## DEVIATION REQUEST AND DECISION FORM

Project Name : Solace Apartments  
 Schedule No.(s) : 5407200052  
 Legal Description : THAT PORTION OF SECTION 7, TOWNSHIP 14 SOUTH, RANGE 65 WEST OF THE 6<sup>TH</sup> P.M., EL PASO COUNTY, COLORADO, DESCRIBED IN BOOK 5046 AT PAGE 748; AND POWERS AND GALLEY PLAZA FILING NO. 1 AS RECORDED IN PLAT BOOK 1-4 AT PAGE 30 OF THE RECORDS OF SAID COUNTY.

A deviation from the standards of or in Section **2.3.7.E for Turn Lane Design** of the Engineering Criteria Manual (ECM) is requested.

LEFT TURN LANE DEVIATION  
 SOLACE APARTMENTS  
 JOB NO. 25174.00  
 7/14/20  
 SHEET 1 OF 1

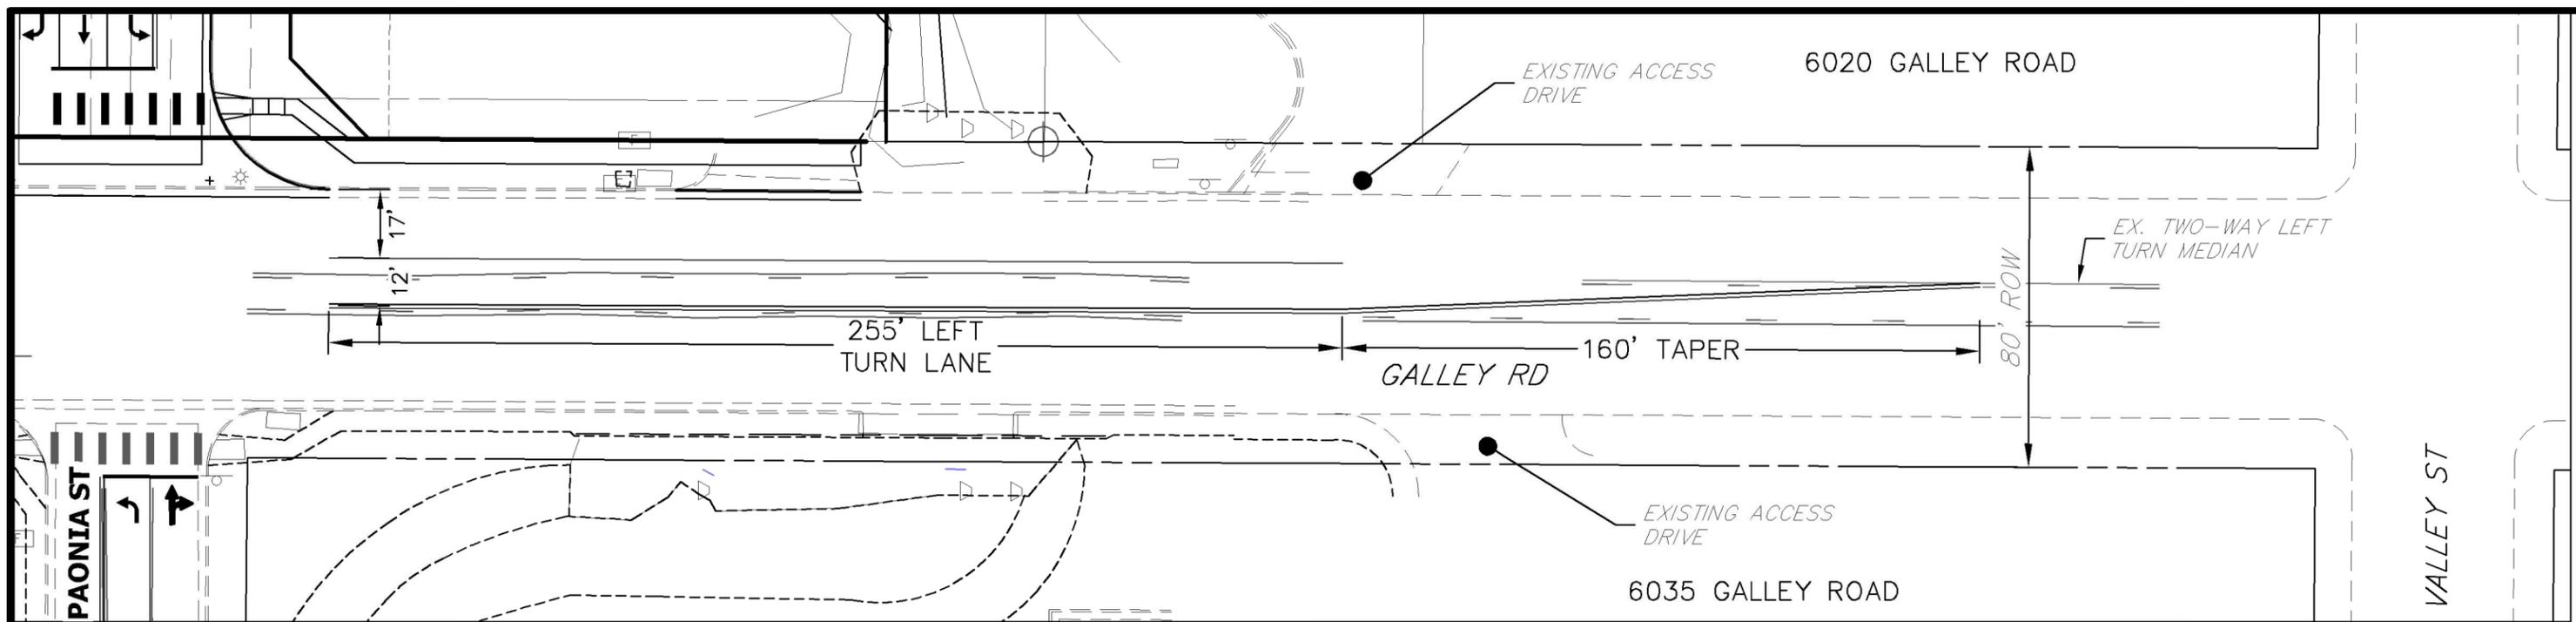
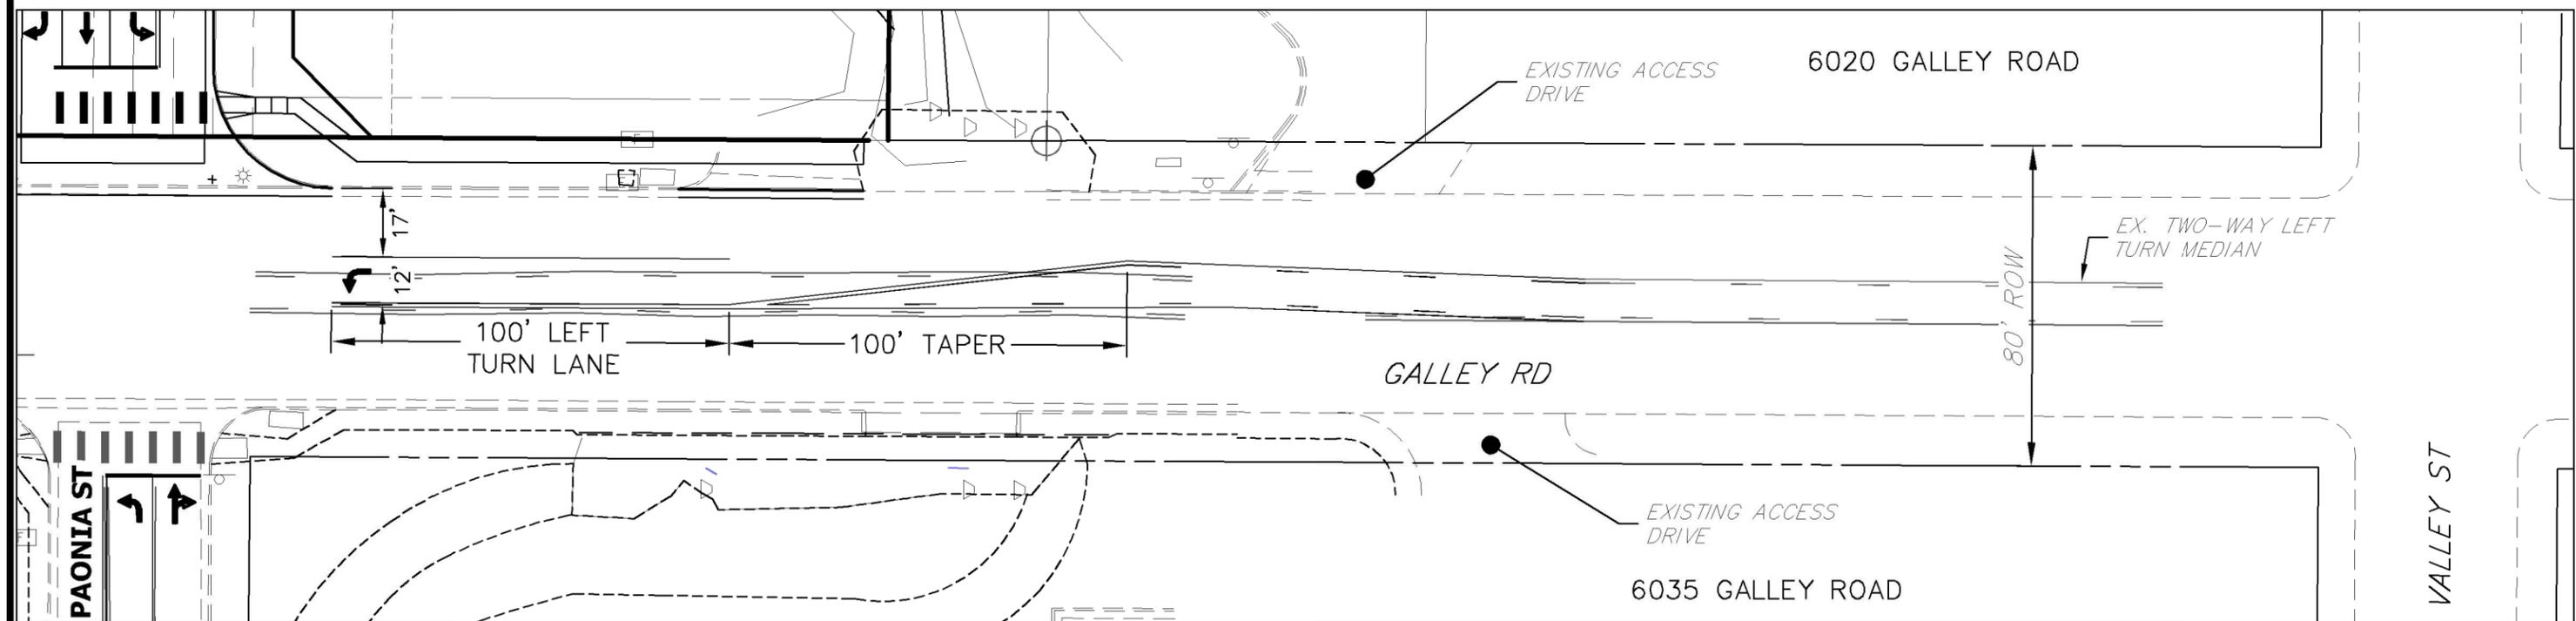
Required deceleration and taper length ECM criteria for a 155' lane length and a 160' taper from Table 2-26 for a 40 MPH design speed.

The reason for the requested deviation of a smaller left turn lane is to prevent restricting turn movements in and out of the surrounding businesses along Galley Road. Accesses for an existing parcel located at 6020 Galley Road and a parcel located at 6035 Galley Road would be directly impacted by the proposed turn lane. The deviation for the proposed design will provide adequate capacity for westbound traffic turning left onto Paonia Street while still providing full movement access to the businesses on the north and south side of galley Road. Per page 2-53, the taper shall also meet the minimum 8:1 ratio. This removes the likelihood of any potential traffic conflicts through this corridor.

The proposed alternative is for the westbound left turn lane located on Galley Road at the intersection of Paonia Street to have a 100' left turn lane and a 100' taper for a total length of 200'. Typical turn lanes, per Chapter 2, Section 2.3.7.E of the ECM for a 40 MPH design speed, require a total length of 415'. Thus, the proposed alternative is 215' shorter than the standard.

The ECM standard is inapplicable to the particular situation due to the fact that existing developments to the north and south of Galley Road have access drives that would be impaired by the addition of a 415' left turn lane and this development should not restrict existing parcel access. The proposed shortened left turn lane would still supply adequate volume for westbound traffic turning left onto Paonia Street, while still allowing the existing access drives to the businesses along Galley Road to retain their full movement.
